ADDENDUM

PROJECT: DOT-200009 Putnam County FSMF

DATE: 02/21/2025

ADDENDUM NO.: 1

E2.1
OFFICE / TRUCK STORAGE
FLOOR PLAN

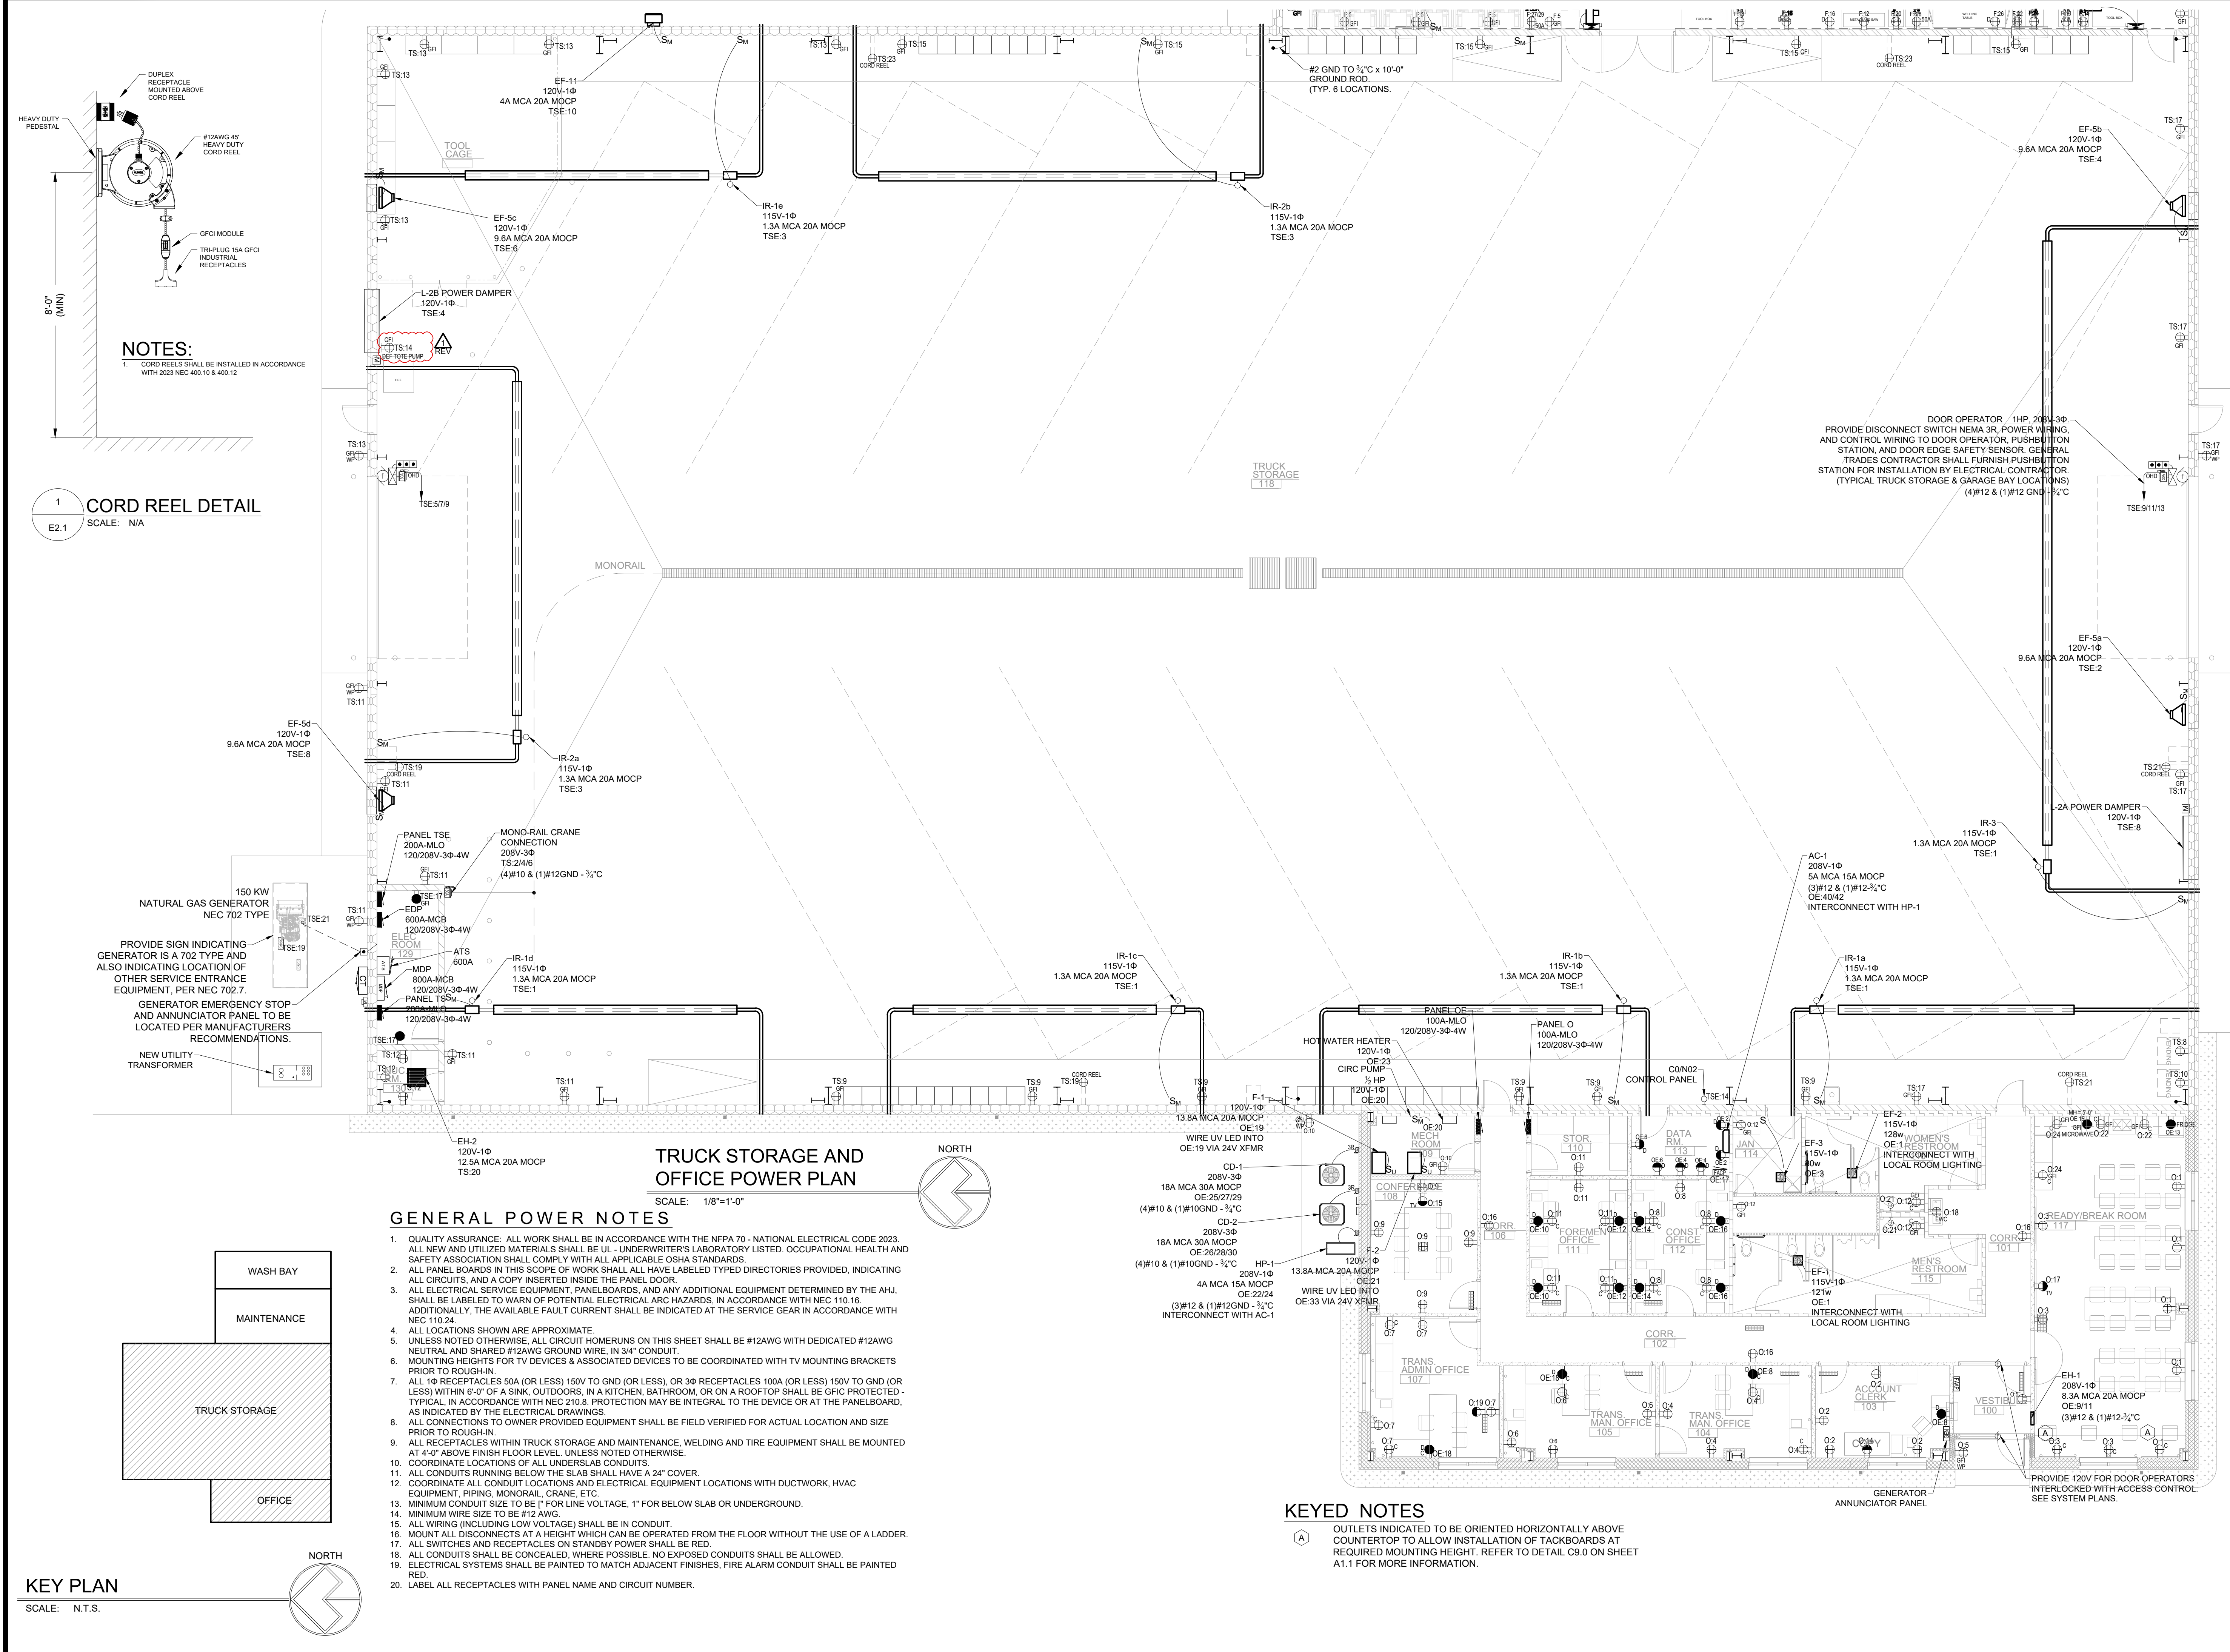
Item #16 Sheet E2.1 Office / Truck Storage Power Plan

- Revision: Drawing was revised to include power to an outlet in the Truck Storage Building. The outlet will be used to power the DEF tote pump.
